PD Modification Application: MM 22-0689
Zoning Hearing Master Date: October 17, 2022 (REMAND)
BOCC CPA Meeting Date: December 15, 2022

1.0 APPLICATION SUMMARY

PETITION NO: MM 22-0689

2.5 Proposed Site Plan (partial provided below for size and orientation purposes. See Section 8.2 for full site plan)

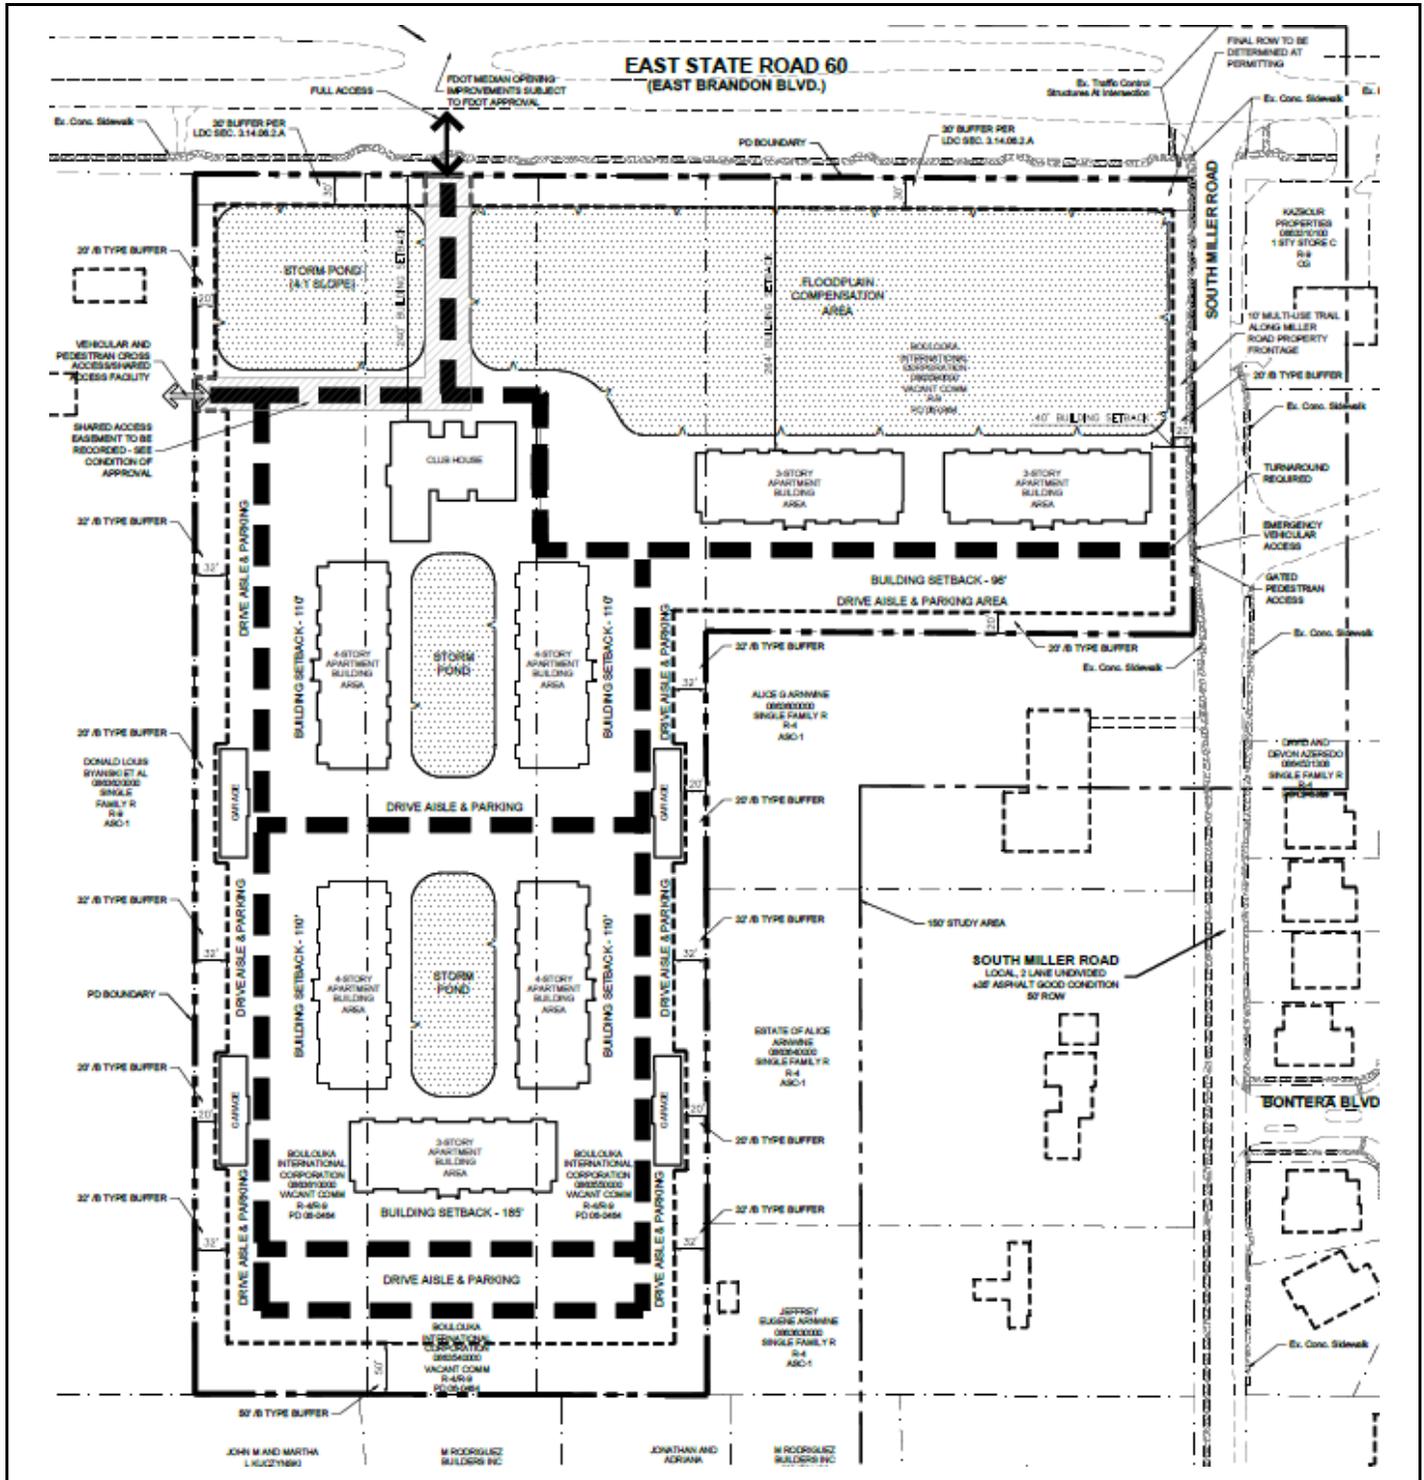
In response to the BOCC's request to re-examine the proposed full access connection on S. Miller Road, the applicant submitted a revised site plan proposing to change the access connection to S. Miller Rd. to a gated emergency access with a pedestrian connection and change the restricted right-in/right-out/left-in access connection on SR 60 to a full access connection. To support the proposed change the applicant submitted a revised site access analysis and reviewed the proposed changes with FDOT staff.

As a result of the proposed access connection changes, FDOT has submitted revised comments with additional site access requirements at the SR 60 project entrance. Additionally, the previously proposed design exception to address the substandard roadway condition has been excluded as the gated emergency access will no longer triggers the LDC, Sec. 6.04.03. L. 1. requirement to improve the roadway to standard. However, staff notes that the applicant is still proposing to build a 10-foot wide sidewalk along the project frontage on S. Miller Rd., as shown on the revised PD site plan.

- The project shall be permitted one full access connection on SR 60, subject to FDOT approval, and one gated emergency access with pedestrian connection onto S. Miller Rd.

- The developer shall construct a 10-foot sidewalk along the project frontage on S. Miller Rd., as shown on the PD site plan.
- The developer shall construct the following site access improvements on SR 60, subject to FDOT approval:

Figure 1: Proposed Building Heights and Buffering and Screening

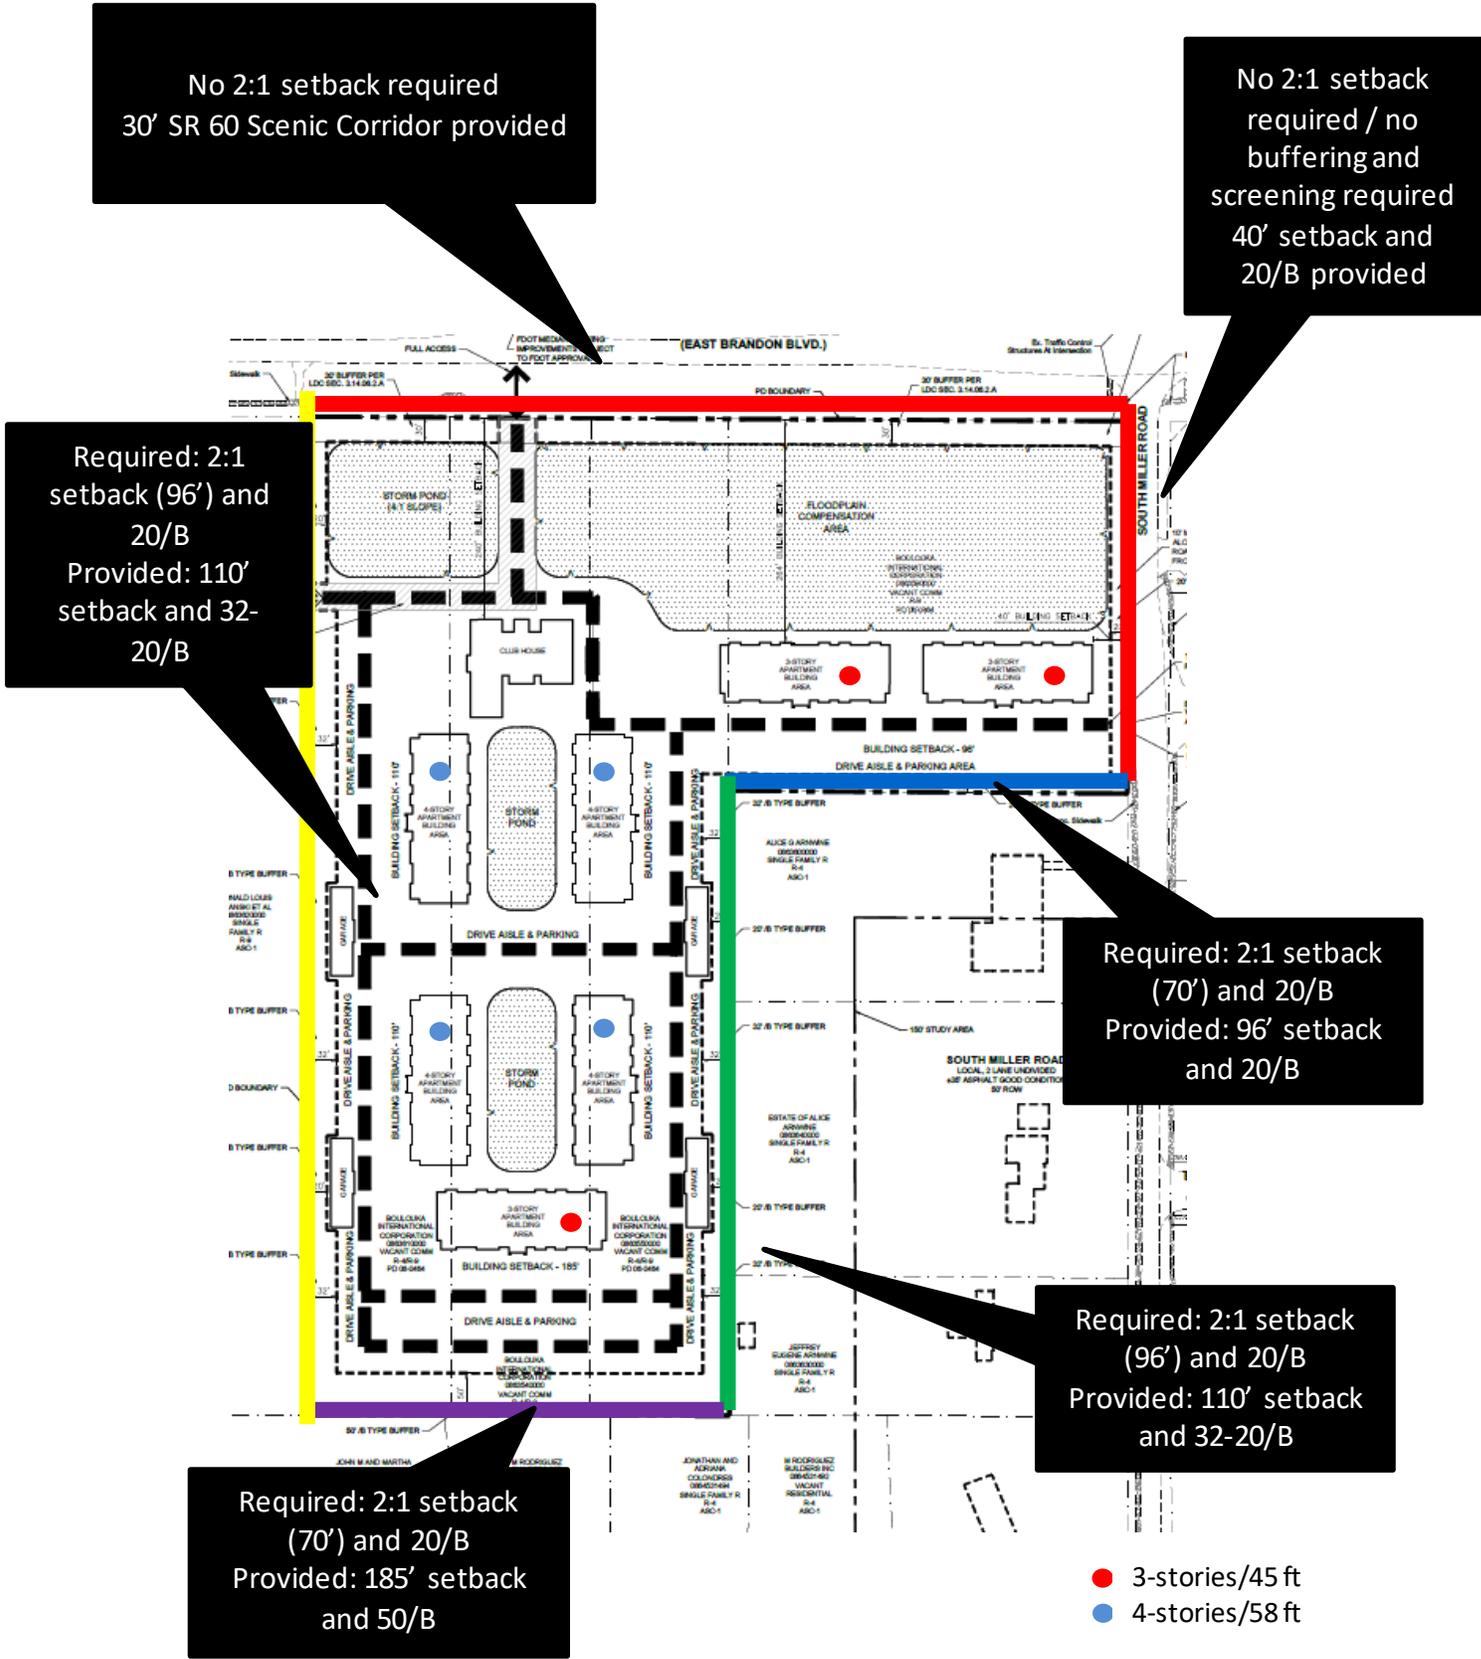
4. Multi-Family building heights shall be limited to a maximum of 58 feet/4-stories or 45 feet/3-stories. Garage building heights shall be limited to a maximum of 15 feet.

5. Buffering at the widths depicted on the general site plan along the western, southern and eastern PD boundaries shall be provided. Type B screening shall be provided within these buffers as specified in conditions ~~1918.1, 1918.2 1918.3, 1918.4 and 1918.5.~~ As depicted on the general site plan, the sidewalk/multi-purpose path along South Miller Road shall be permitted to encroach into the required buffer along South Miller Road.
